## Highbrook Precinct Private Plan Change Request: Response to further information request under clause 23 of Schedule 1 of the RMA

**Date** 12 December 2022

**From** Sukhi Singh, Technical Director Planning

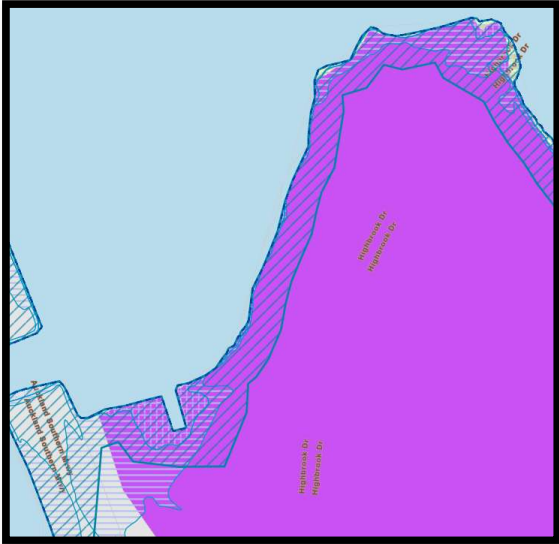
| Category of information   | Council Request  | Applicant's Response   |
|---|--|--|
| <p>3. Traffic Effects of SH1 Southbound / Highbrook Road / Hellaby's Road Roundabout upon Subject Site Intersection</p> | <ul style="list-style-type: none"> <li>• Please provide additional assessment of potential mitigation measures to ensure that vehicular access to and from the subject site is not adversely affected by queueing from the roundabout at the motorway interchange.</li> <li>• The ITA forecasts peak hour queue lengths on Highbrook Drive which would extend northwards beyond the proposed site access intersection. However, it does not propose mitigation to ensure that the subject site access intersection will be able to function safely and efficiently without being adversely affected by traffic effects from the downstream motorway interchange roundabout.</li> <li>• This information is required to confirm that safe and efficient vehicular access to and from the subject site can be achieved, which in turn underpins strategic objectives of the THAB zone, to ensure integration with adjoining land uses and efficient access to activities such as employment, education and retail opportunities and other services.</li> </ul> | <p>As discussed with the Council representatives in earlier communication and building on the earlier communication with AT/ WK during the pre-lodgment period, the transportation assessment reported within ITA concludes that there are a number of existing constraints imposed on the private vehicle traffic generation associated with the Plan Change site. The ITA assessment and proposed conditions of the Plan Change sought to provide a balanced transport outcome involving promotion of travel options as well as the recognition of those current constraints to minimise peak period trip generation within an existing trafficked road network.</p> |
